MONTICELLO NUCLEAR GENERATING PLANT

AMENDMENT TO FACILITY OPERATING LICENSE

Amendment No. 56
License No. DPR-22

ATTACHMENT TO LICENSE AMENDMENT NO. 56

Figure 3.4-1 Sodium Pentaborate Solution Volume Concentration Requirements

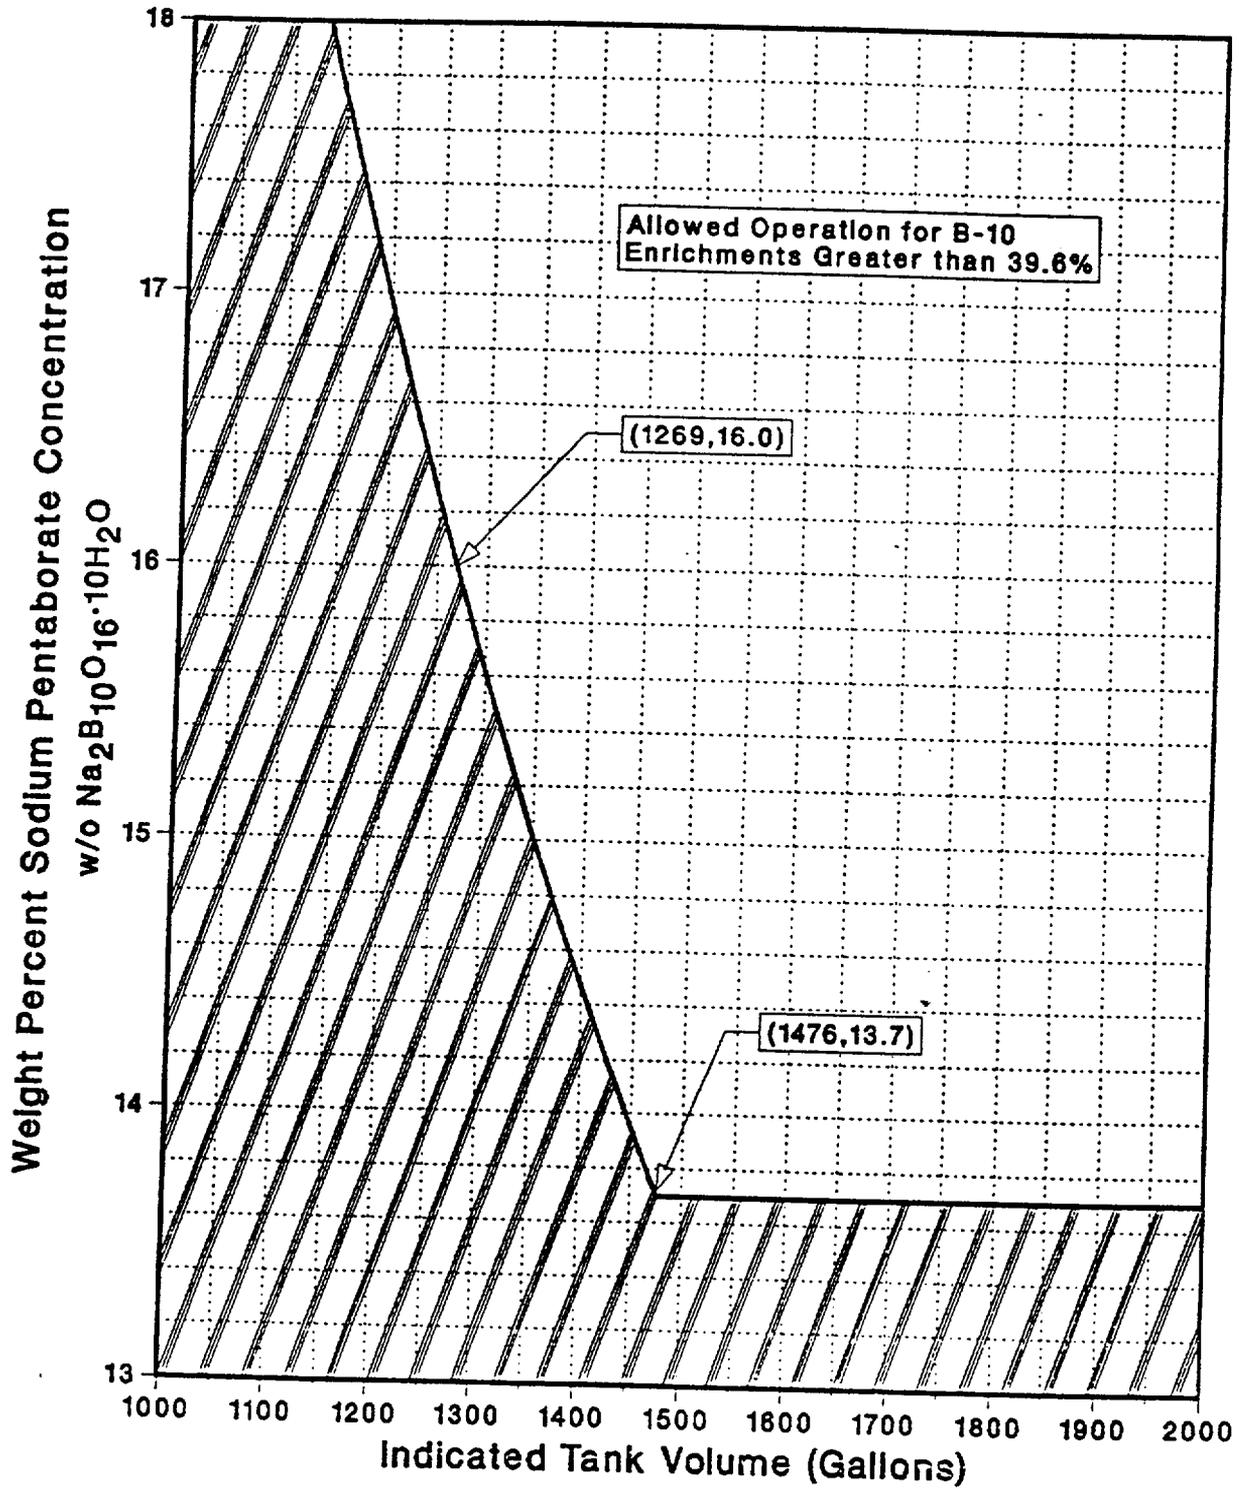
1. The liquid poison tank shall contain a boron bearing solution that satisfies the volume, concentration and enrichment requirements of Figure 3.4.1, or compliance can be demonstrated by satisfying the following equations:

$$V \geq \left(\frac{71.18}{0.0051xC + 0.998} \right) \left(1 + \frac{4821}{1101-E} \right) \left(\frac{19.8}{E} \right) \left(\frac{100}{C} \right) + 128 \text{ gal}$$

$$C \geq 8.28 \left(\frac{86}{Q} \right) \left(\frac{19.8}{E} \right)$$

Figure 3.4-2 Sodium Pentaborate Solution Temperature Requirements

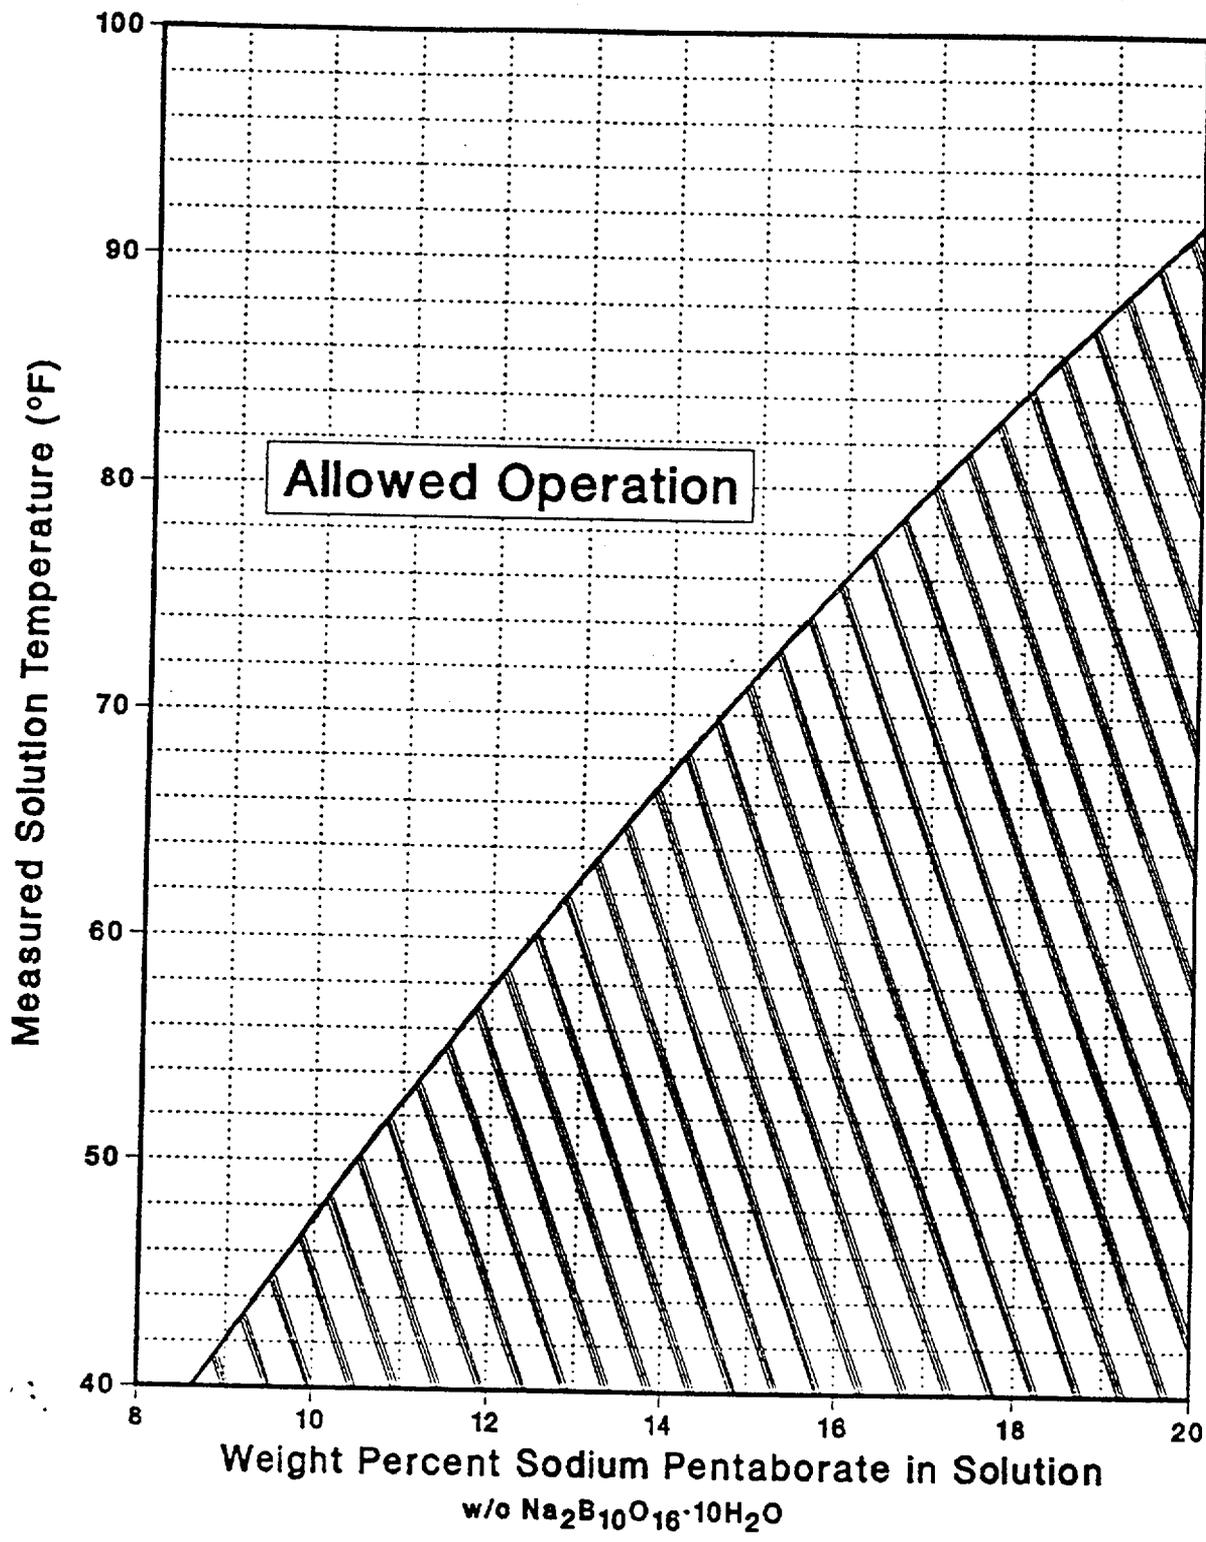
- a. Compliance with Equation 2 is demonstrated within 7 days or
 - b. The Commission shall be notified and a special report provided outlining the actions taken and the plans and schedule for demonstrating compliance with the ATWS Design Basis.
2. The temperature shall not be less than the solution temperature presented in Figure 3.4.2.
 3. The heat tracing on the pump suction lines shall be operable whenever the room temperature is less than the solution temperature presented in Figure 3.4.2.

Boron concentration shall be determined. In addition, the boron concentration shall be determined any time water or boron are added or if the solution temperature drops below the limits specified by Figure 3.4.2.

- C. The solution saturation temperature varies with the concentration of sodium pentaborate. The solution will be maintained at least 5 F above the saturation temperature within the tank and suction piping to guard against precipitation. The 5 F margin is included in Figure 3.4.2. Temperature and liquid level alarms for the system are annunciated in the control room.
